Case 2100 Quick Attach and FurrowJet Bracket Installation (141214)

March 28, 2023 UPDATE:

Fig. 1

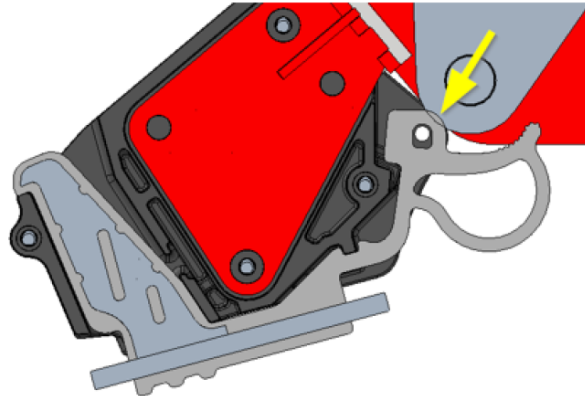
In some instances of FurrowJet on Case 2100 (Kit 141214), interference has been observed between the current version of the FurrowJet Pivot Bracket (having the retaining loop which was previously a tab) and the shank as shown in Fig 1:

This interference can prevent FurrowJet from snapping in place. If you find this to be the case, it is recommended to cut or grind the rear portion of the retaining loop as shown in Fig. 2:

Fig. 3 (141219 Rev. 6)

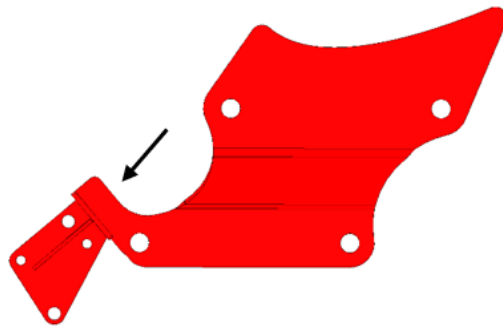
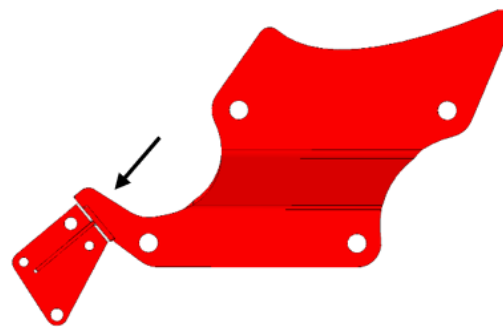
This only applies to Revision 6 and older 141219 Weldments. Revision 7 moves the FurowJet location to resolve the issue. The revision can be identified by the profile difference shown in Figures 3 & 4:
